Addendum to Appendix P

Anadromous and Resident Fish Streams

Technical Report

DECEMBER 2005

JOB NO: 26219699	DRAWN BY: TEK\PLB	Figure 1
DATE: August, 2005	FILE: M: Data\ADOT\Juneau Access\Figures/Tech Report Figures\Anadromous/Addendum Figure 1 - Fish Streams

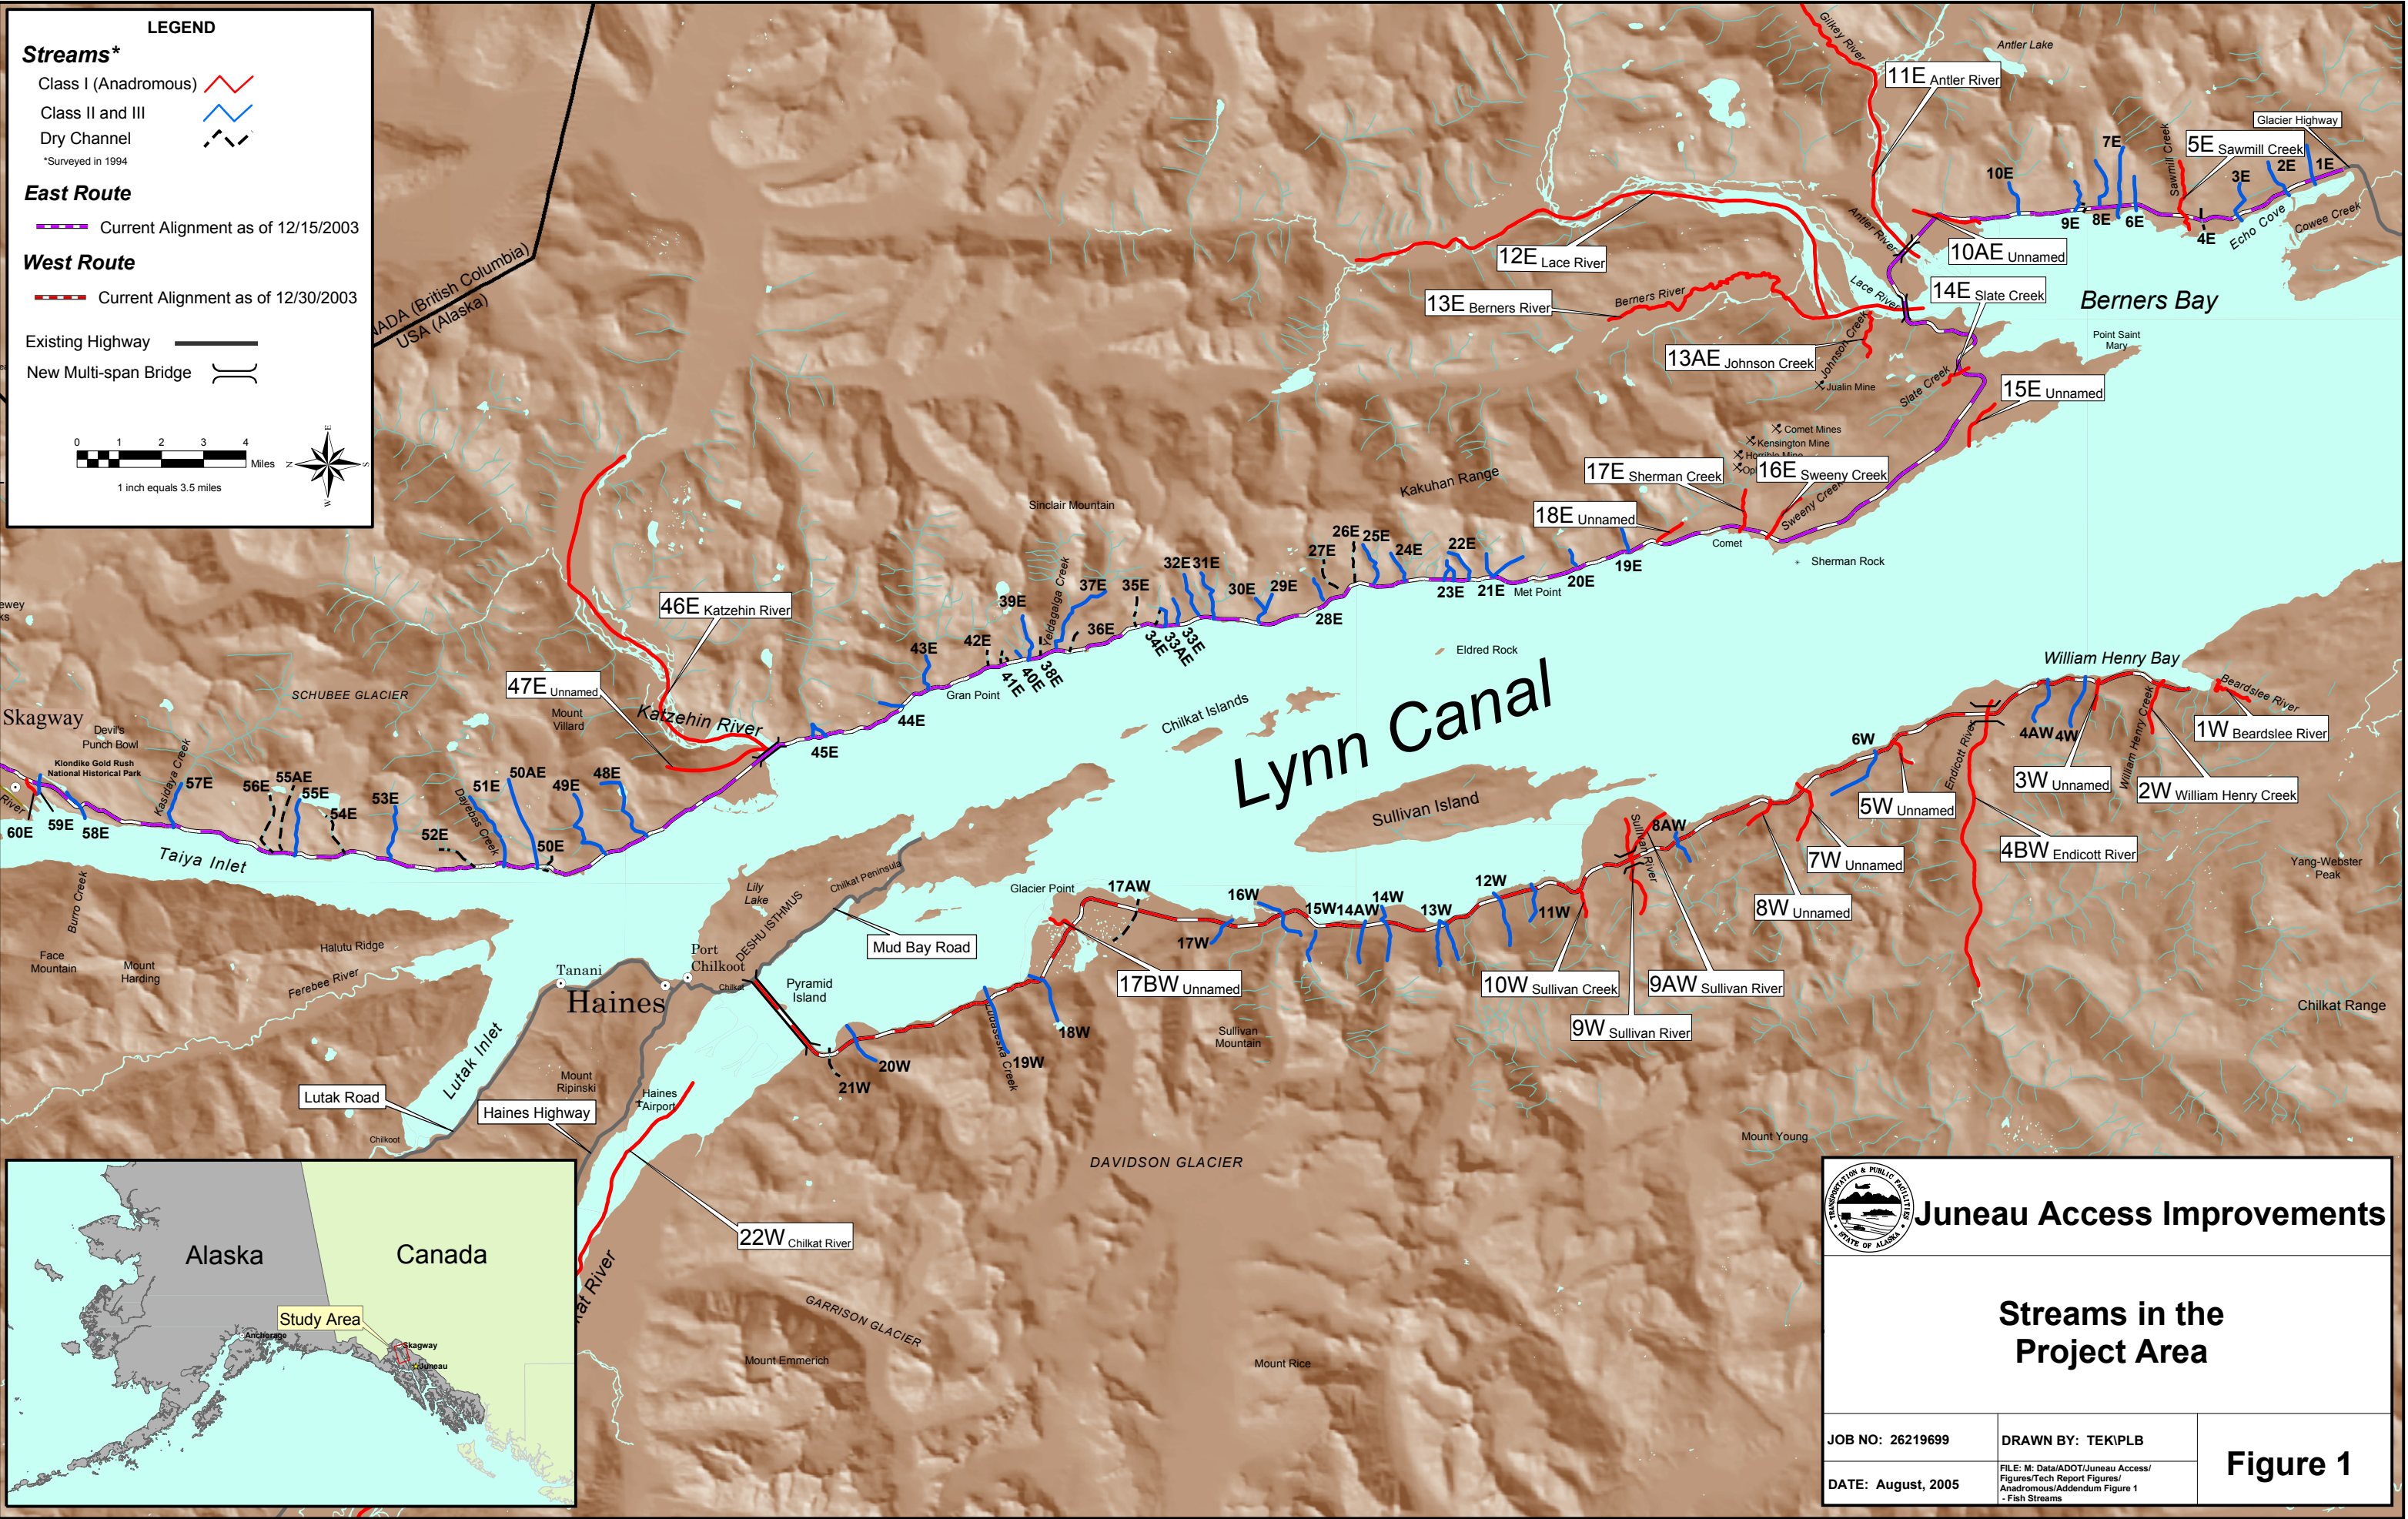
This section presents Figure 1, “Streams in the Project Area.” The figure is a revised version of Figure 3-1 that was originally provided in the 2004 technical report. Below is a listing of revisions included in Figure 1:

- Stream 6E: Stream 6E is correctly depicted as a Class IIA stream and not as a dry channel, as was the case in the October 2004 Figure 3-1.
- Stream 7E: Stream 7E is correctly depicted as being south of its location on the October 2004 Figure 3-1, as was originally depicted on the 1997 DEIS figure.

- Stream 8E: In the October 2004 Figure 3-1, stream 8E appeared to be an outlet of Stream 9E. In the revised Figure 1, stream 8E has been correctly identified as located south of stream 9E at the location labeled stream 7E in the October 2004 Figure 3-1.

- Stream 9E: The configuration of stream 9E has been revised. In the October 2004 Figure 3-1, stream 9E appeared to have two forked outlets; however, if there are two outlets, one outlet is currently dry. The revised stream configuration, presented in Figure 1, now matches the 1997 DEIS figure.

- Sturgill’s (#59E) and Pullen (#60E) creeks have been added to Figure 1.
